ALERT SERVICE BULLETIN

NO. 205A1-01-82

MODEL AFFECTED: 205A-1

SUBJECT: CHIP DETECTOR ASSEMBLY, TEDECO B3703

FIGURE 1

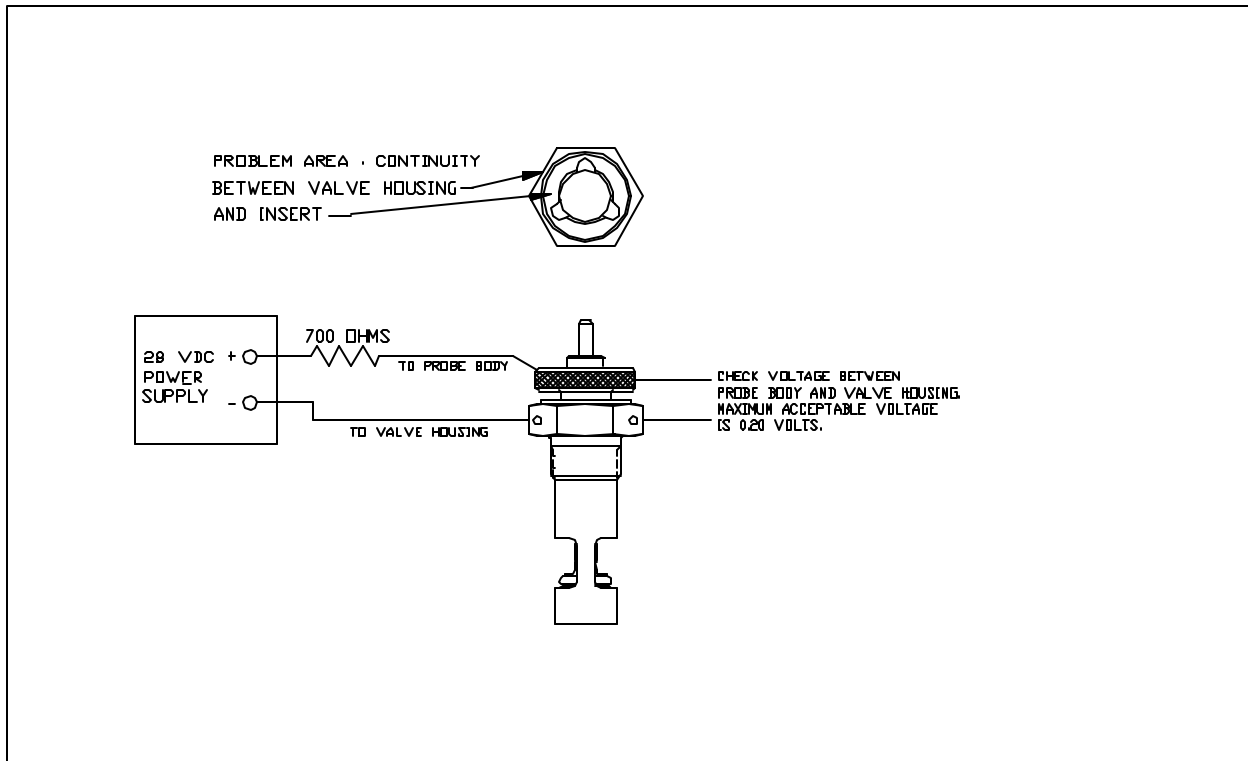
1. Connect the chip detector to a 28 Volt DC power supply using a 700 ohm, 2 watt resistor as shown in Figure 1.
2. Measure the voltage between the probe body and the valve body. The voltage drop must be 0.20 volts or less across the unit. If the voltage drop is larger than 0.20 volts, then return the unit to Tedeco (See 3. Part Replacement.)

(A current supply can be used, set to 40 mA, or another voltage can be used with an appropriate series resistor. The resistance is the voltage drop across the unit divided by the current.)

FIGURE 2

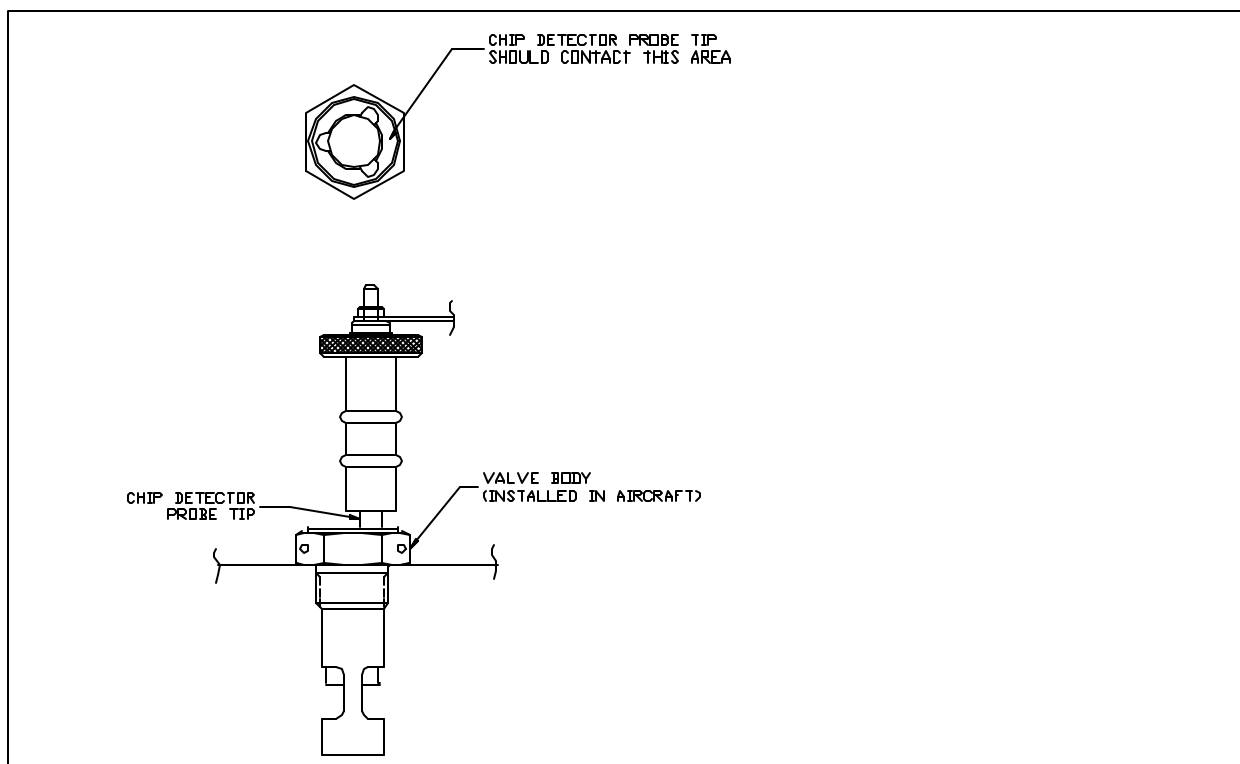
1. Ensure that electrical power is supplied to the chip detector.
2. Remove the chip detector probe from the self-closing valve.
3. Hold the tip of the center stud of the chip detector probe firmly against the steel insert as shown in Figure 2 while checking chip indicator light in cockpit. If the cockpit light illuminates, the unit is acceptable. If the light does not illuminate, then proceed to the next step.

FIGURE 3

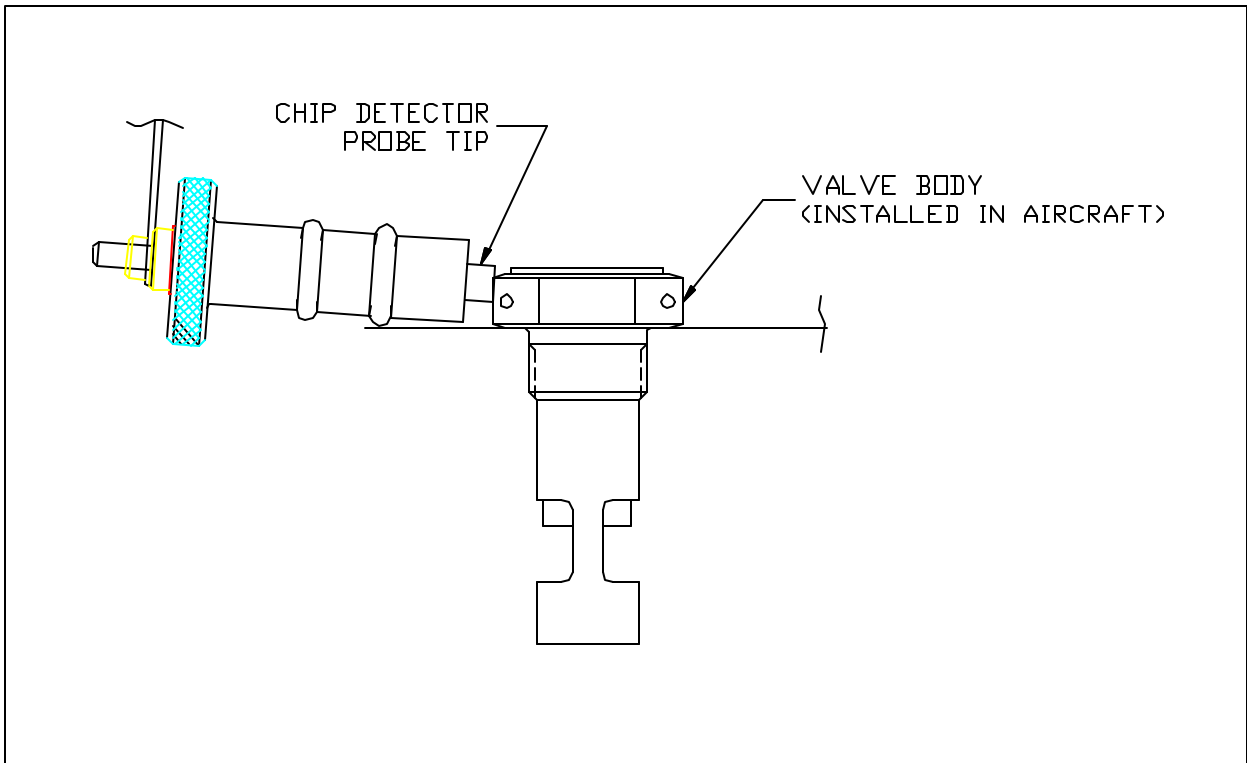
4. Hold the tip of the center stud of the chip detector probe firmly against the valve housing as shown in Figure 3 while checking chip indicator light in cockpit. The cockpit light should illuminate. Illumination of the light in this step isolates the electrical discontinuity to the valve insert. Repair the unit per the repair instructions in section 2 of this document.

If the light still does not illuminate during this check of the valve housing, there is an electrical discontinuity somewhere else in the circuit. Check the remaining electrical circuit between chip detector and cockpit indicator light.

FIGURE 4A

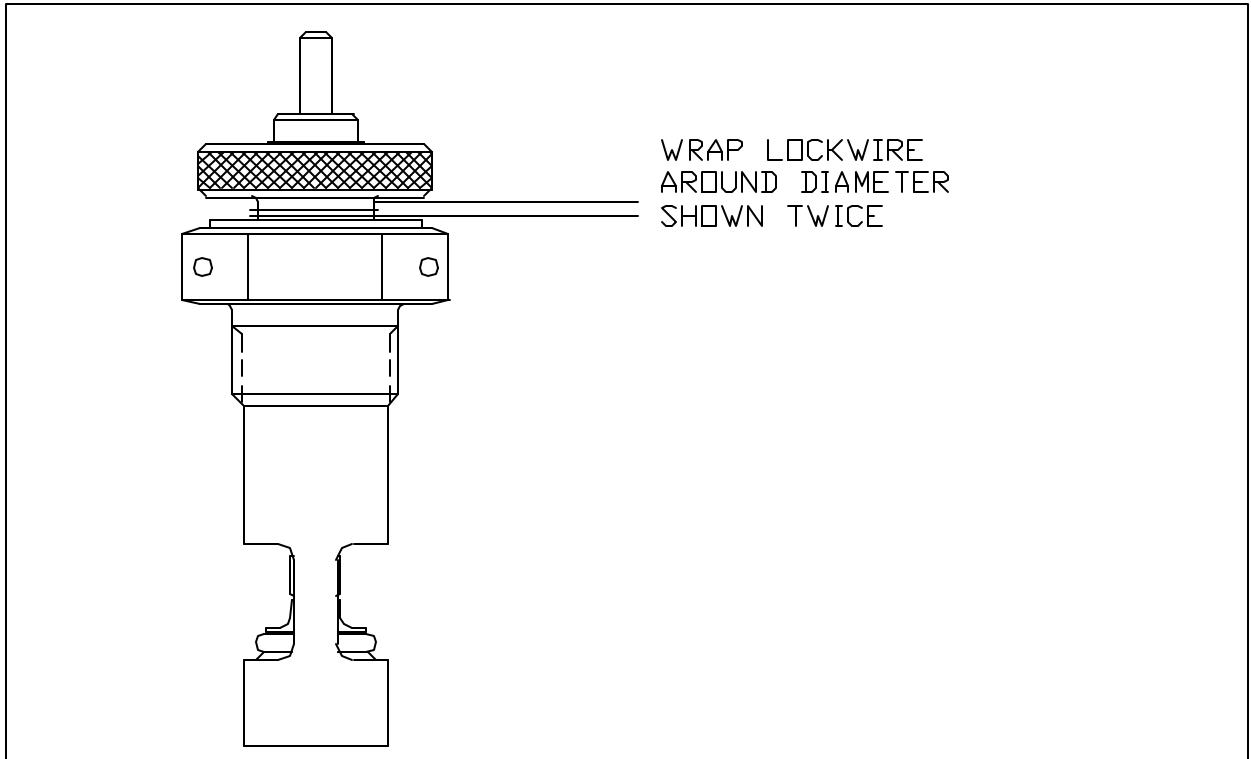
- 2.1. Install Chip Detector Probe into Valve assembly.
- 2.2. Tightly wrap a piece of lockwire (approx 6 inch length) around the chip detector probe diameter shown two full times. (See Figure 4A.)

FIGURE 4B

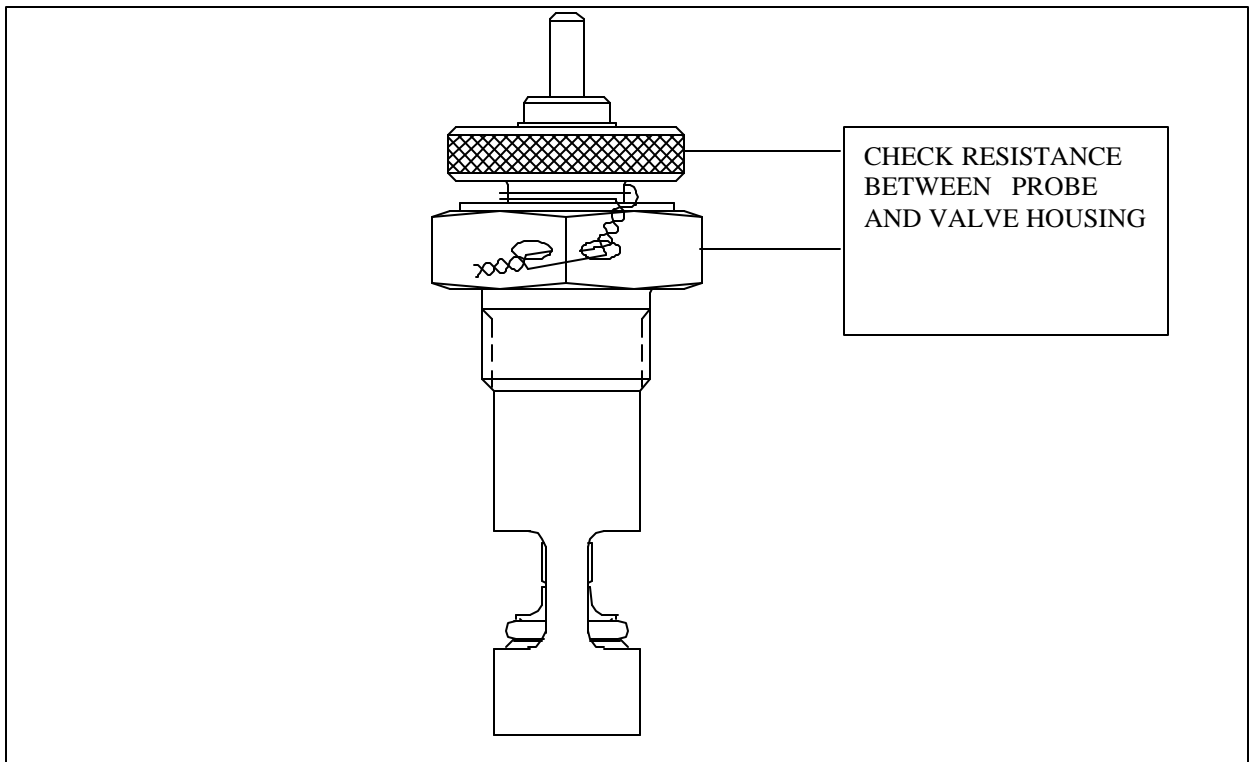
- 2.3. Twist two ends together approximately five times until twisted section reaches nearest free lockwire hole. Ensure that lockwire is tightly wrapped.
- 2.4. Slide one end of lockwire through the lockwire hole. Continue twisting two ends together to complete the lockwiring. (See Figure 4B.)
- 2.5. Check repair by using an ohmmeter to check resistance between the chip detector probe and the valve housing. Resistance should be 1 ohm maximum. (See Figure 4B.)
